NOTICE TO ALL CONTRACTORS:

Proposal #07: 5780-03-61, WISC 2025026
Wauzeka - Soldiers Grove
STH 60 to 0.49 Mi E
Railway St
STH 131
Crawford County

5780-03-81, WISC 2025028
Wauzeka - Soldiers Grove
0.49m E Railway St to
Sunnyridge Rd
STH 131
Crawford County

This is Addendum No.01, which provides for the following:

SHEET 1 OF 10
266

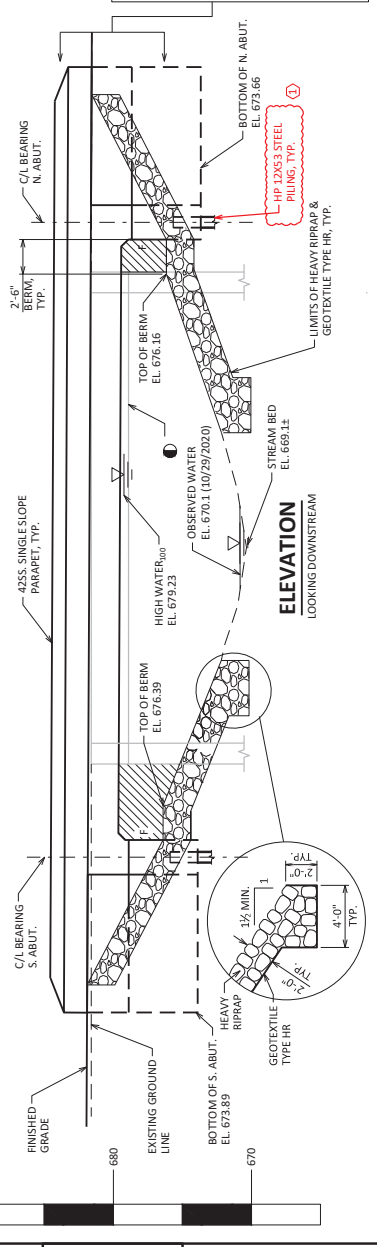
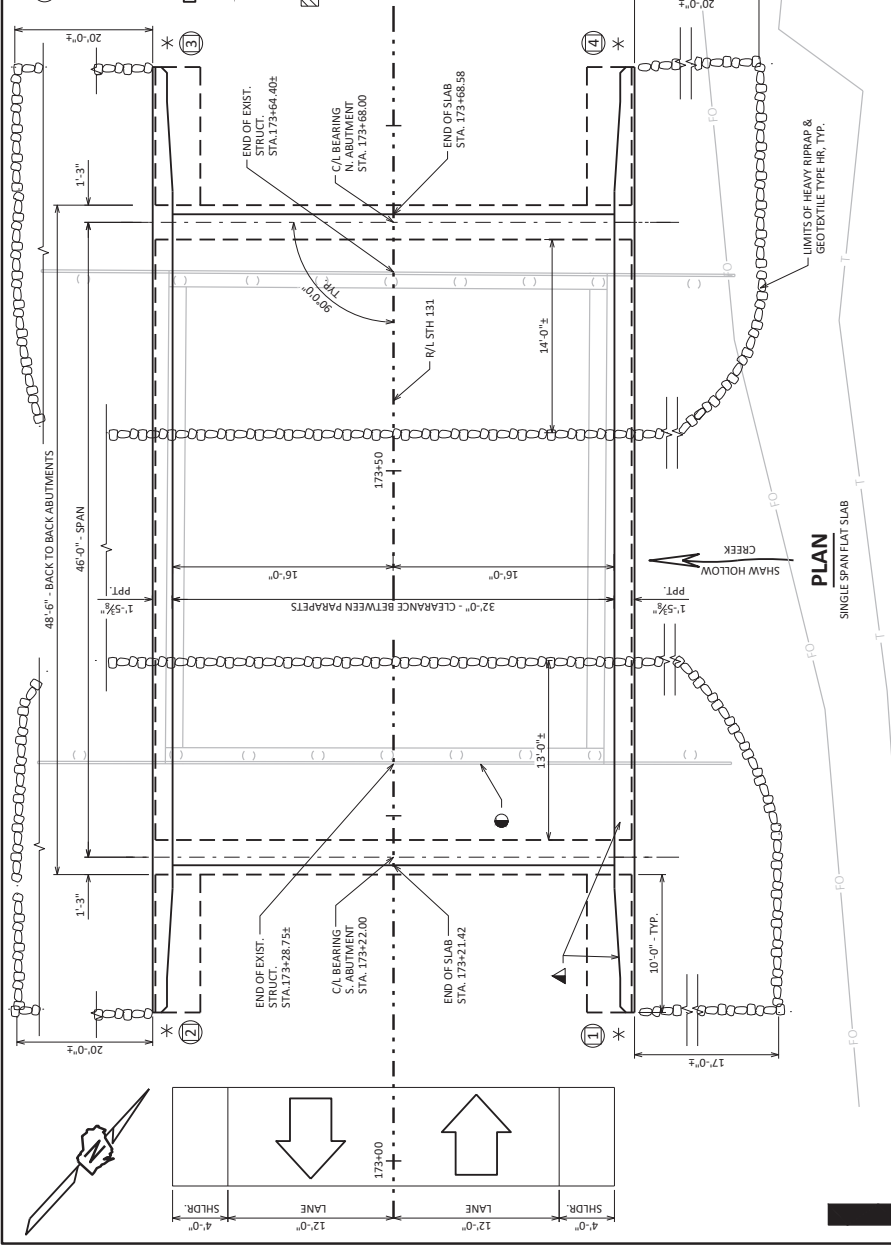
Revised Plan Sheets – 5780-03-81	
Plan Sheet	Plan Sheet Title (brief description of changes to sheet)
266	Structure B-12-255, piling type change required for the abutments.
267	Structure B-12-255, piling type change required for the abutments.
268	Structure B-12-255, piling type change required for the abutments.
269	Structure B-12-255, piling type change required for the abutments.
271	Structure B-12-255, piling type change required for the abutments.

AT ABUTMENTS HP 12X3 STEEL PILING MAY BE USED IN lieu of HP 10W42 STEEL PILING. PAYMENT SHALL BE BASED ON BID PRICE FOR HP 10W42 STEEL PILING.
